Request for Class II Permissive Change(C2PC)

FCC ID: VG8XM9P02YYP

Please be notified that we, the undersigned, **Guangdong Midea Kitchen Appliances Manufacturing Co., Ltd.** declare that the reasons for this class II permissive change are as below:

This is a C2PC application for which the previous grant was issued on 05/12/2023.

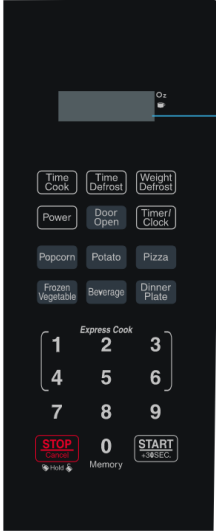
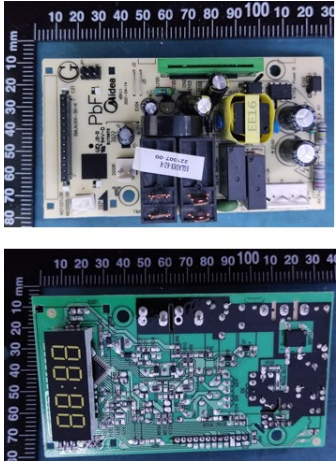
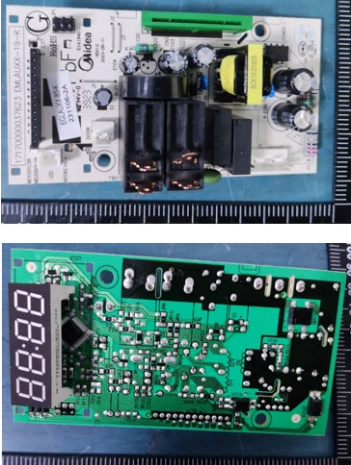
No.:	Original	New	Difference(s)
1			Keypad: Updated front keypad to accommodate child lock function (Child resistant oven door function)
2	 	 	Mother board: Modified the peripheral circuit (non-RF circuit) and some individual components and PCB layout. The magnetron and other circuit are exactly same as before

3	Not Applicable		The new one adds a solenoid valve locking mechanism, the original is not.
---	----------------	---	---
